Preliminary review of the "Draft Water Sharing Plan Review of the Barwon-Darling Unregulated and Alluvial Water Sources 2012" report prepared by the Natural Resources Commission.

Daren Barma of Barma Water Resources was asked to undertake a review of the "Draft Water Sharing Plan Review of the Barwon-Darling Unregulated and Alluvial Water Sources 2012" report prepared by the Natural Resources Commission.

Figure 1: Proportion of all extractions in Barwon Darling compared to inflows (Data Sourced from NSW DPIE, NSW Water Register, and WaterNSW Real Time Data)

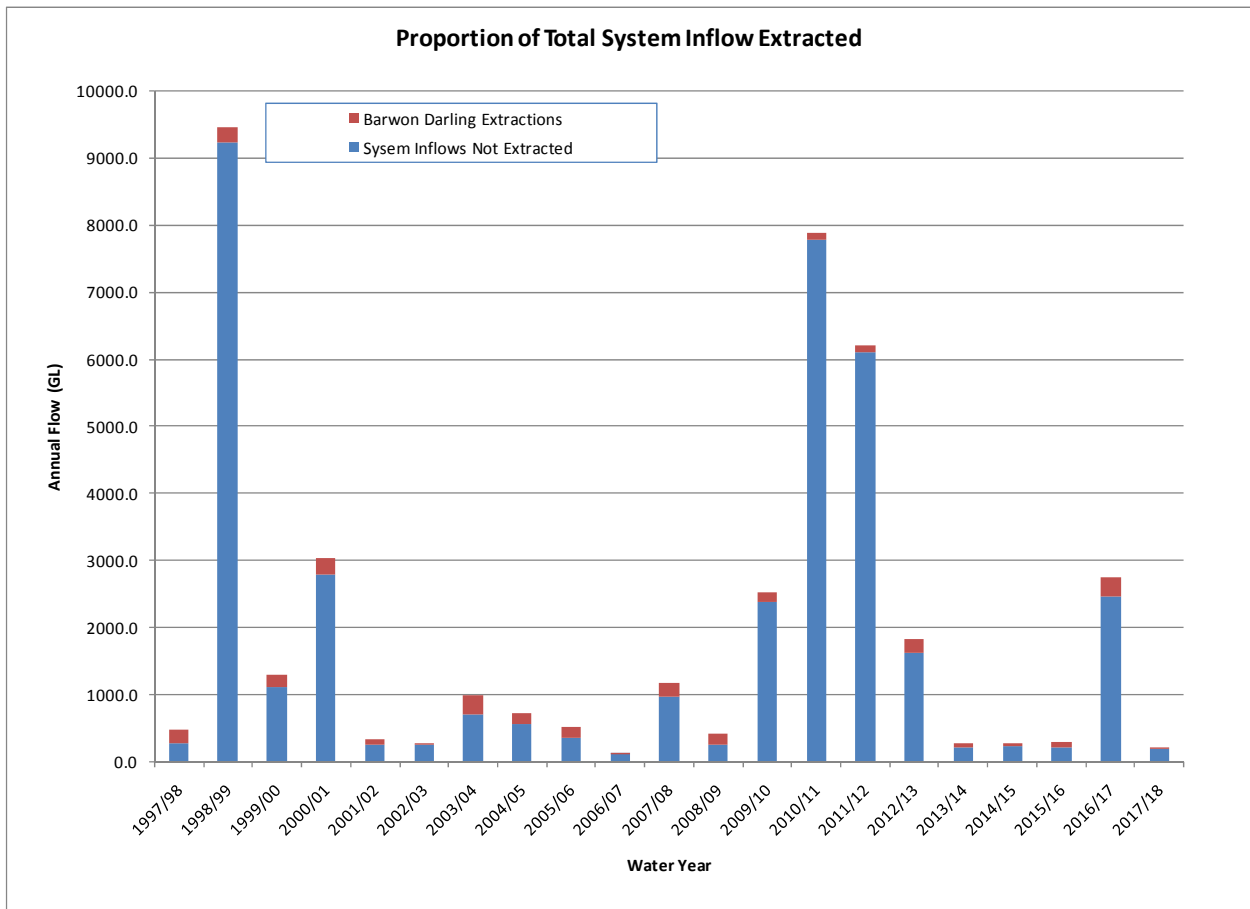
vi) The report compares total system extractions to flows at Bourke. This is hydrologically flawed, extractions should be compared to total system inflows, so as not to have proportions skewed by transmission losses along the Barwon Darling. A figure like the one below would be better.

Figure 2: Porportion of A Class extraction compared to 1250ML/d at Warraweena (Data Sourced from NSW DPIE, NSW Water Register, and WaterNSW Real Time Data)

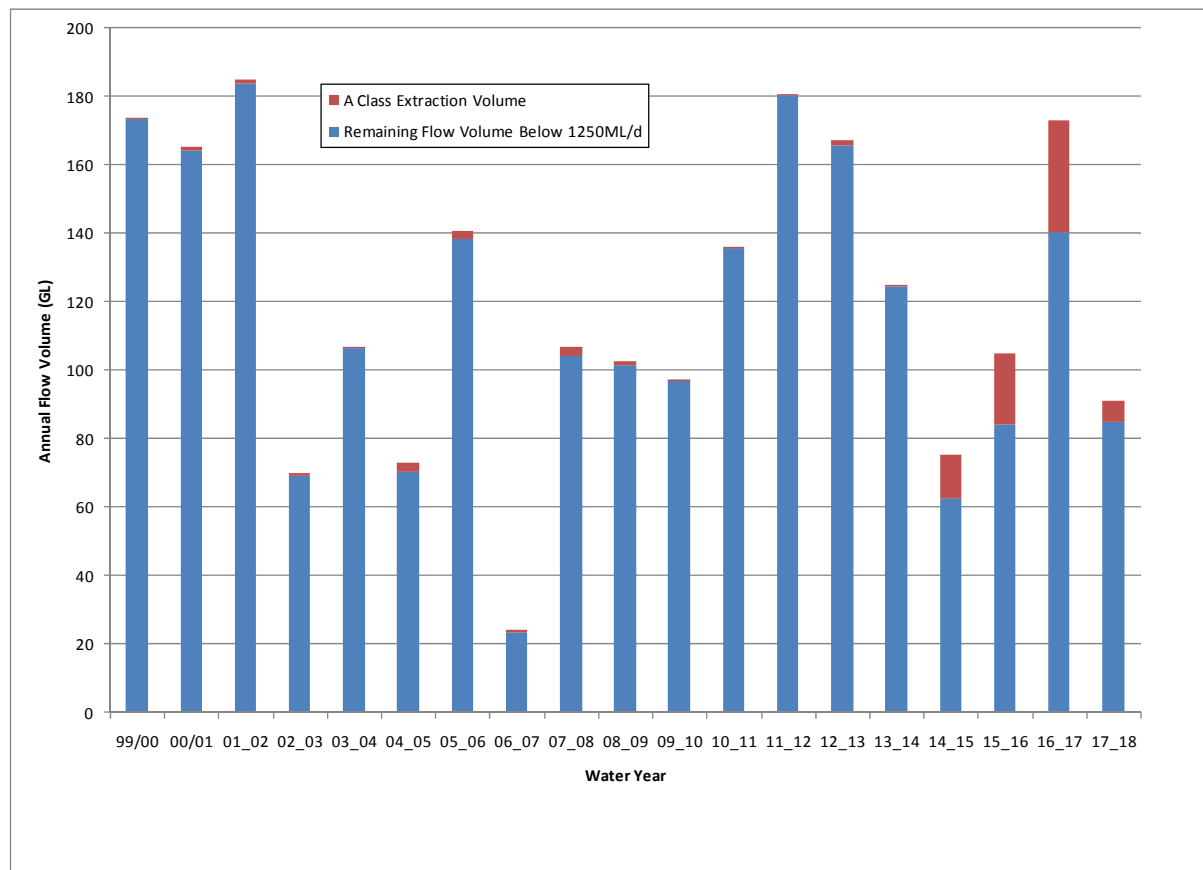
The volume of A class extraction relative to the flow volume below 1250ML/d at the Warraweena Gauge.() is shown below. Warraweena is upstream of most A Class extraction and 1250ML/D is the upper bound for A Class extraction at the Bourke Town Gauge. Whilst A class extraction has increased from 2014/15 onwards it is still a small proportion of the annual volume.
